NEBRASKA ARMY NATIONAL GUARD
Wahoo Readiness Center Addition

PROJECT NO. 31030344

A D D E N D U M N O . 1

7 EAST WALL INTERIOR ELEVATION
 1/4" = 1'-0"

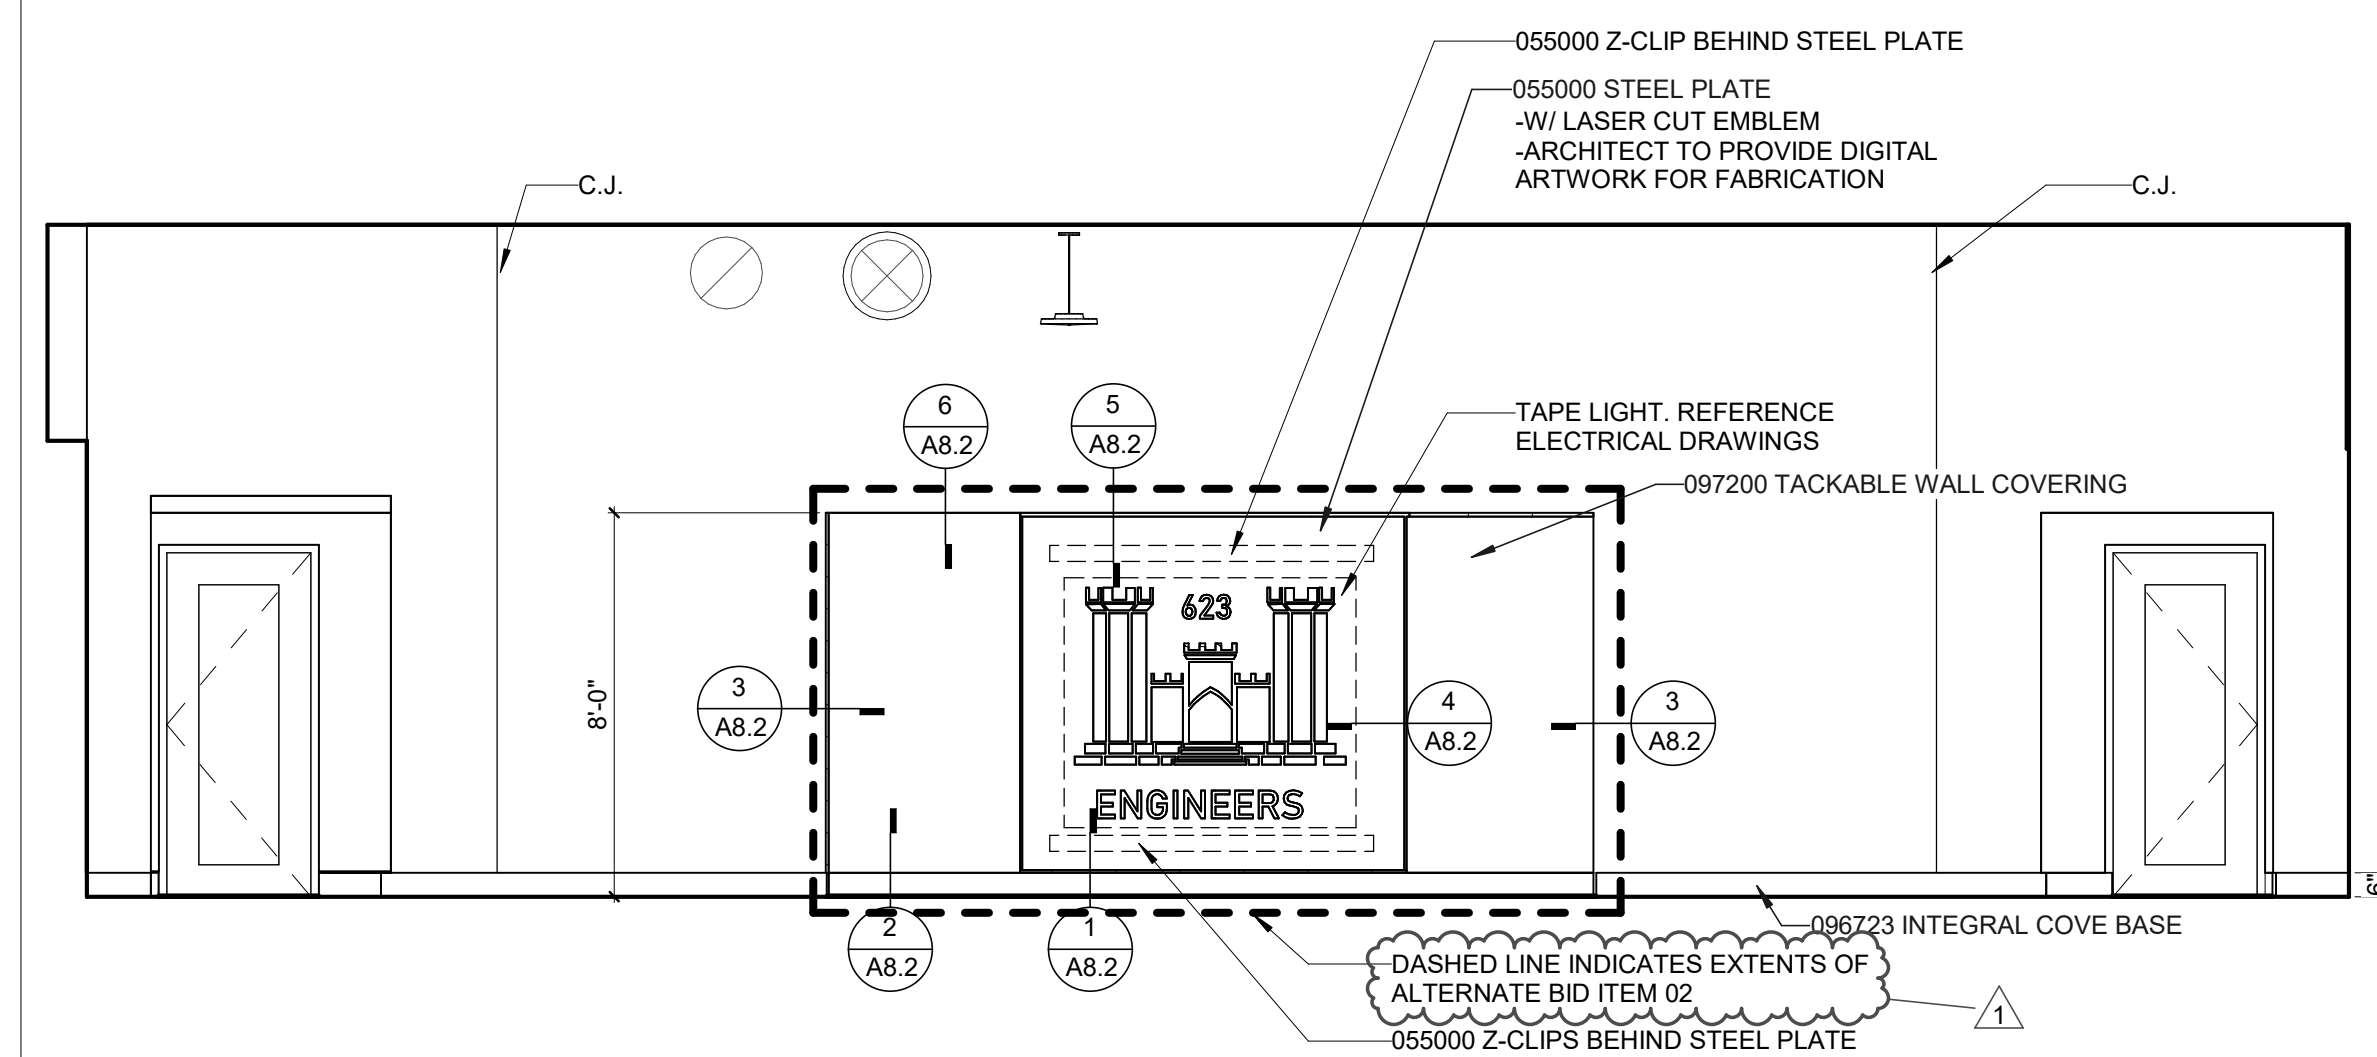
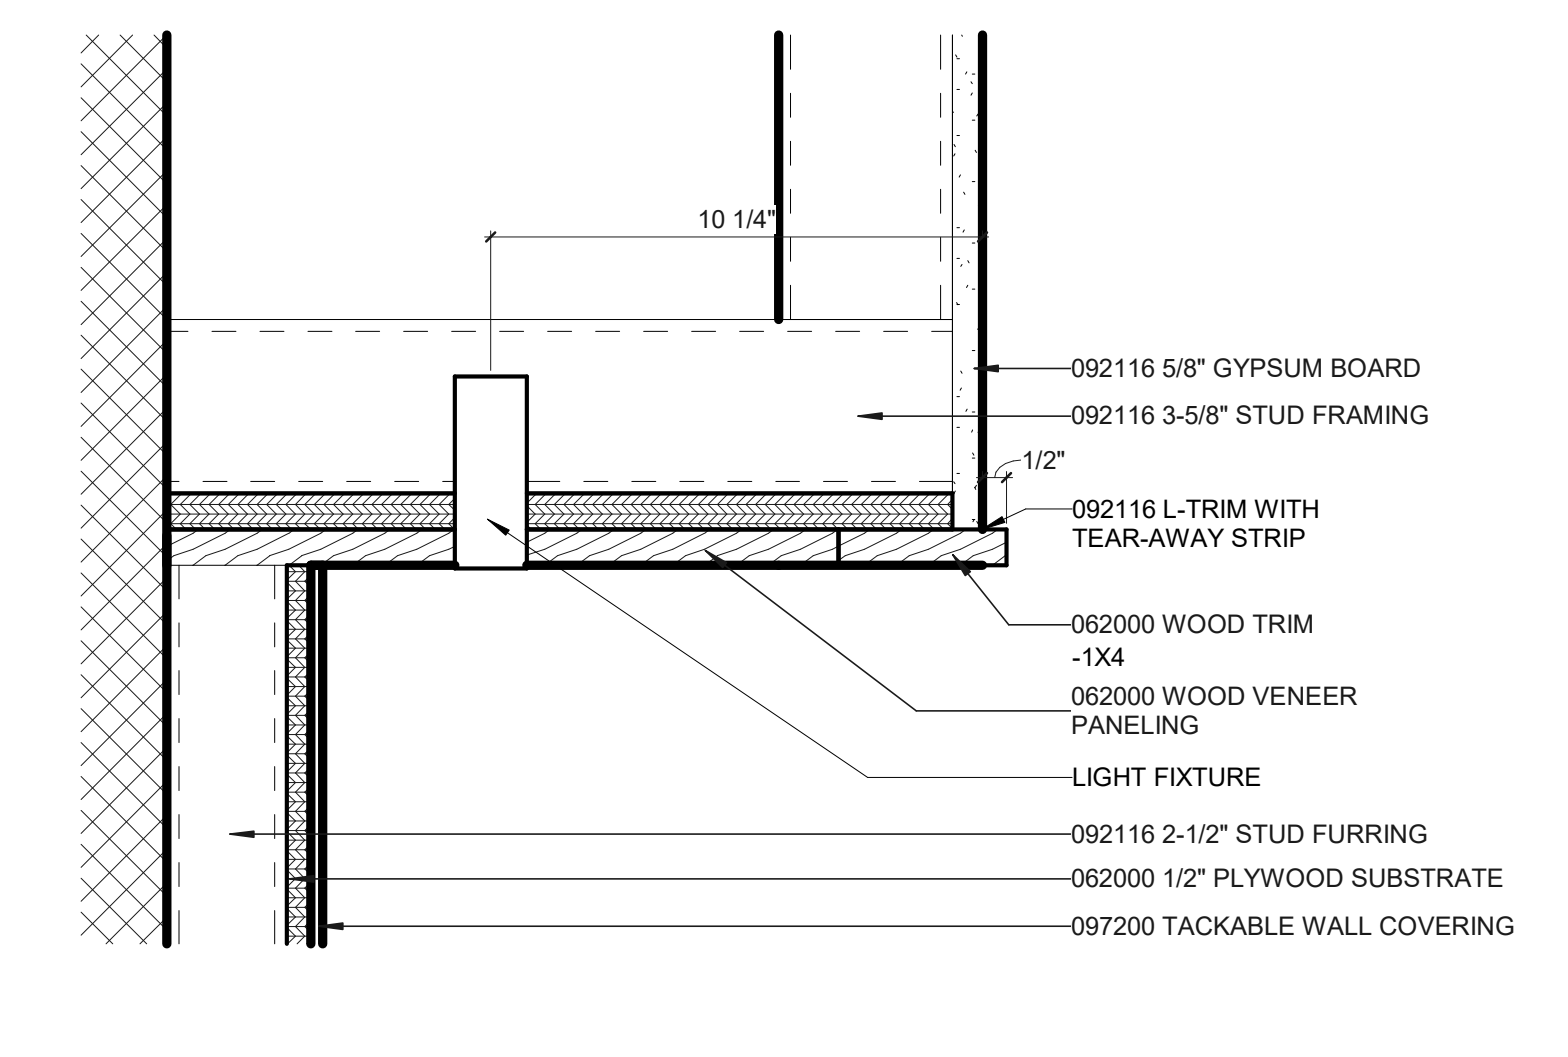
- 6. Sheet A1.1 FIRST FLOOR PLAN
 - a. FIRST FLOOR PLAN: Alternate bid item number corrected.
- 7. Sheet A8.2 INTERIOR ELEVATIONS & DETAILS
 - a. Detail 7: Alternate bid item number corrected.

1 FIRST FLOOR FINISH PLAN
 1/8" = 1'-0"

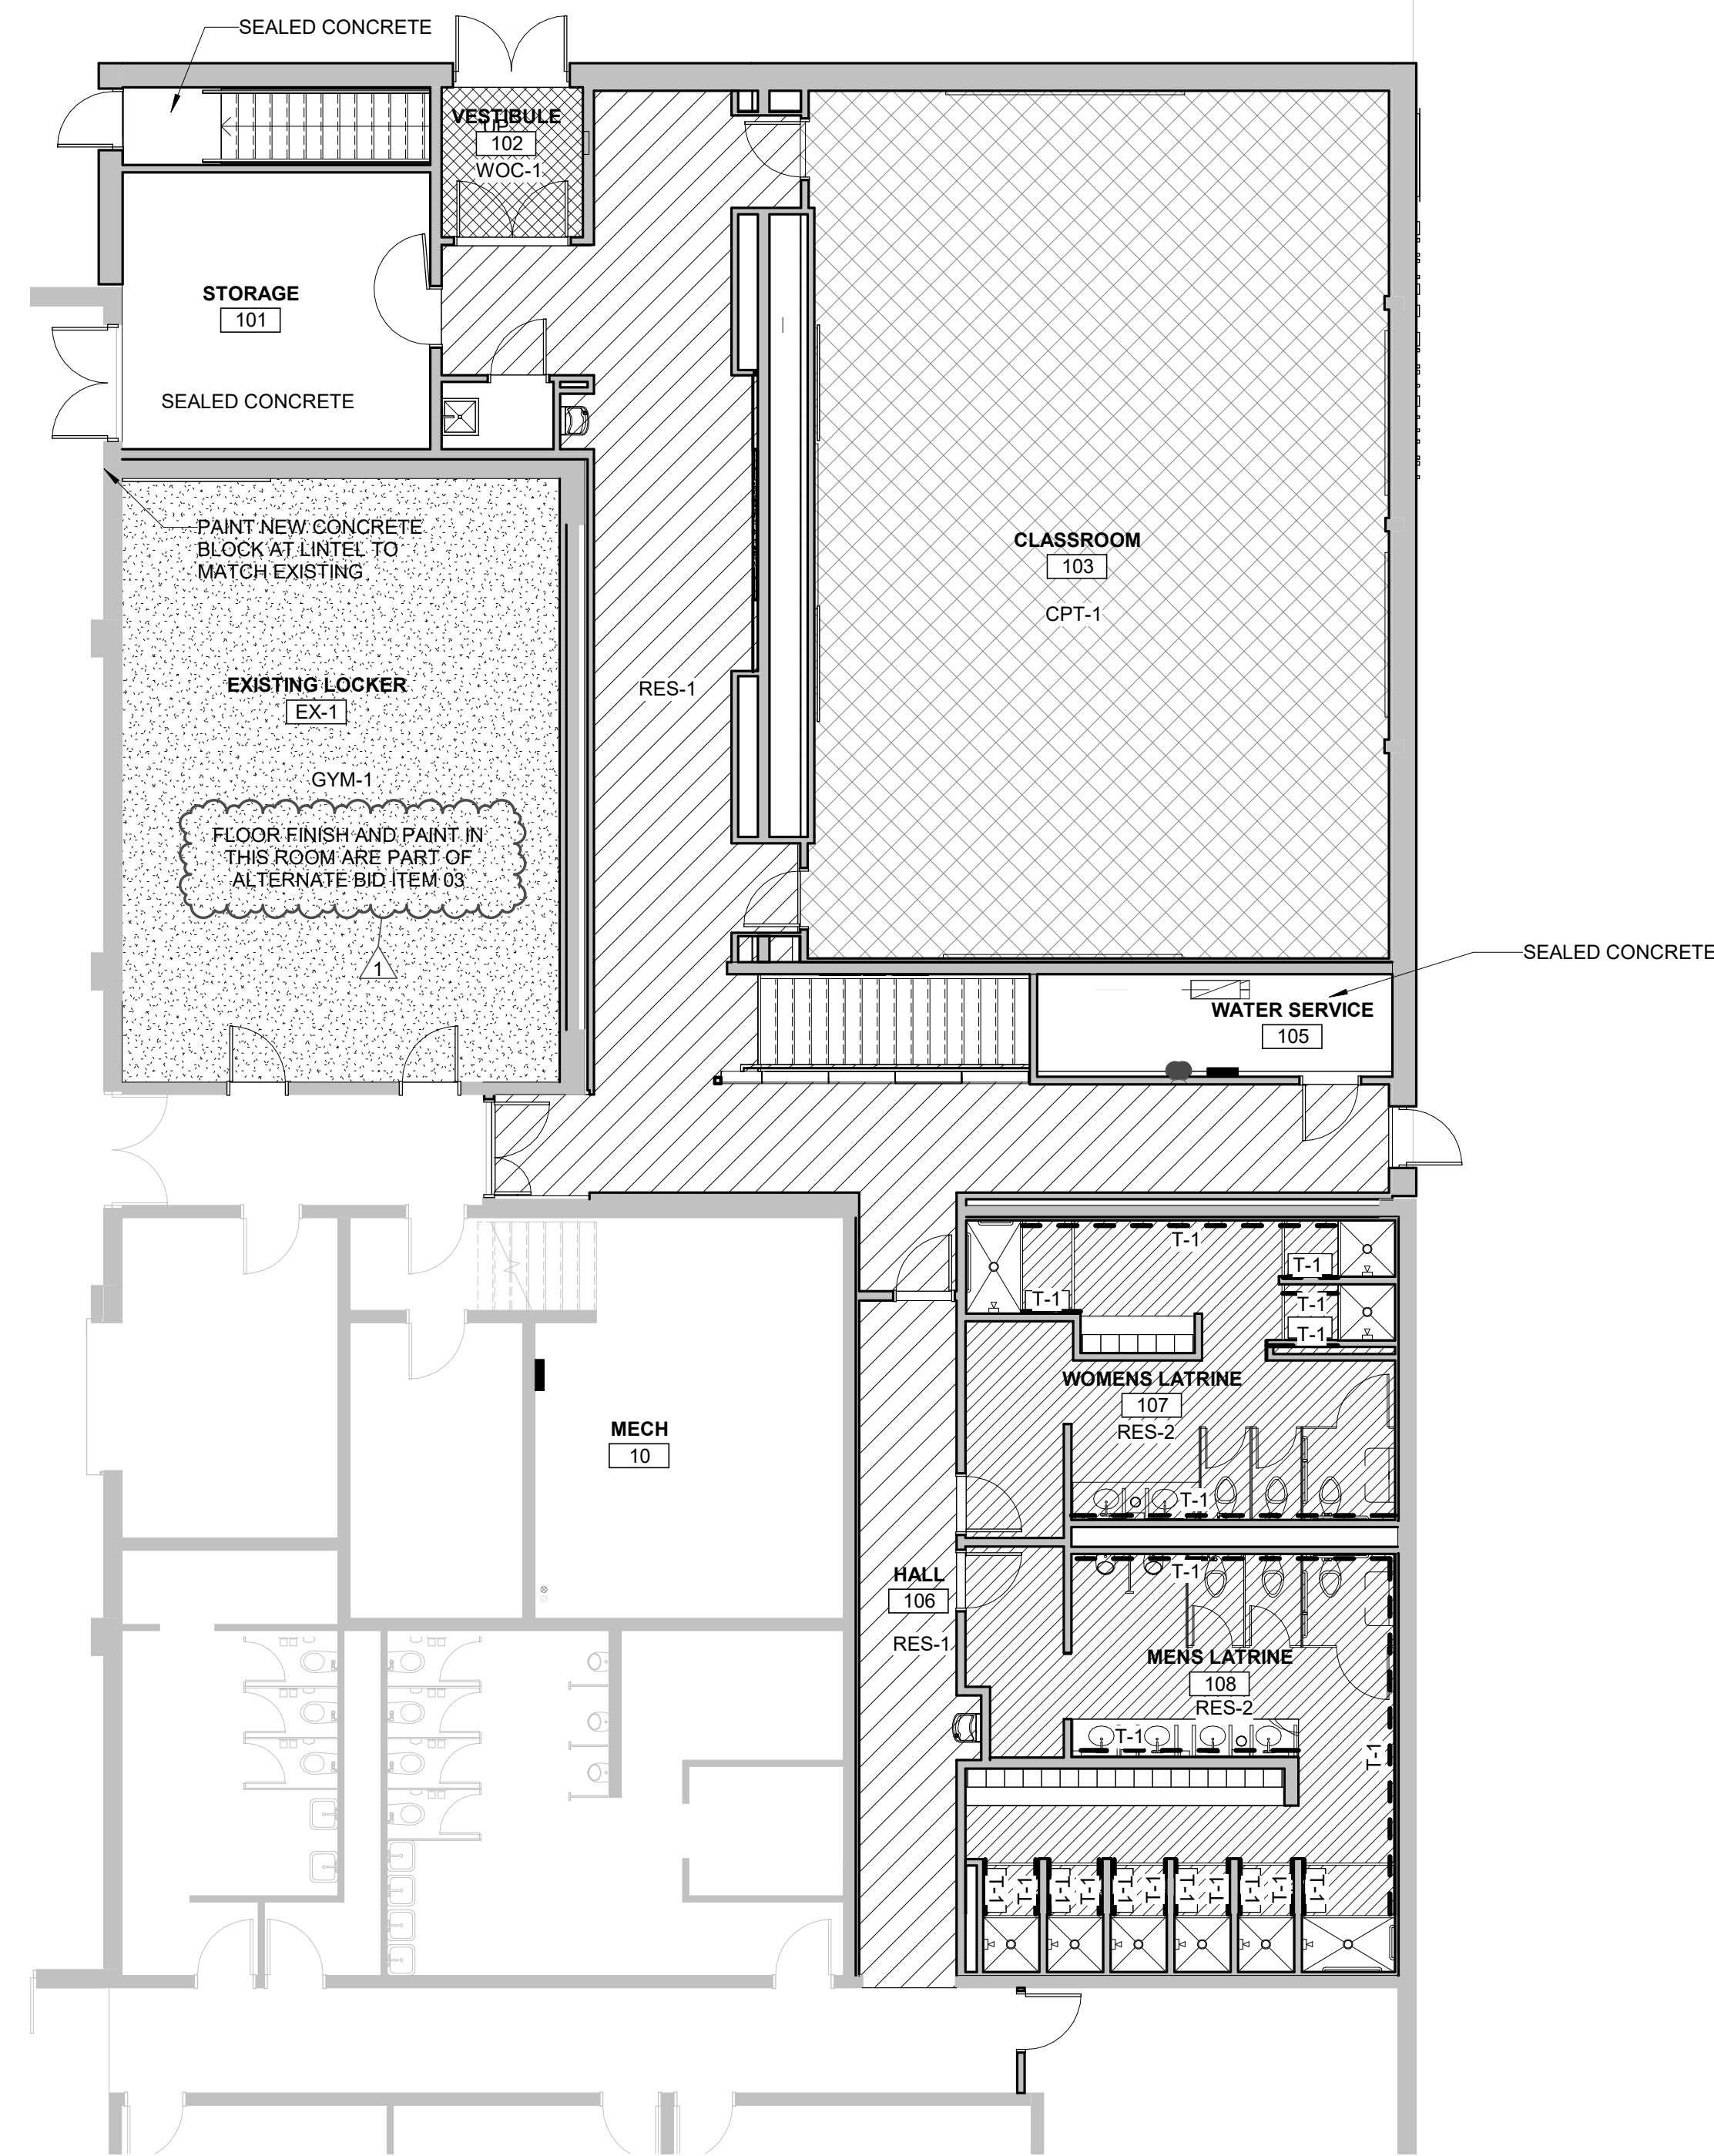
- 8. Sheet A9.1 FINISH PLANS
 - a. Detail 1: Alternate bid item number corrected.
- 9. Sheet M1.1 First Floor Mechanical Plans
 - a. Sheet note #20, changed ABI #2 to ABI #3.
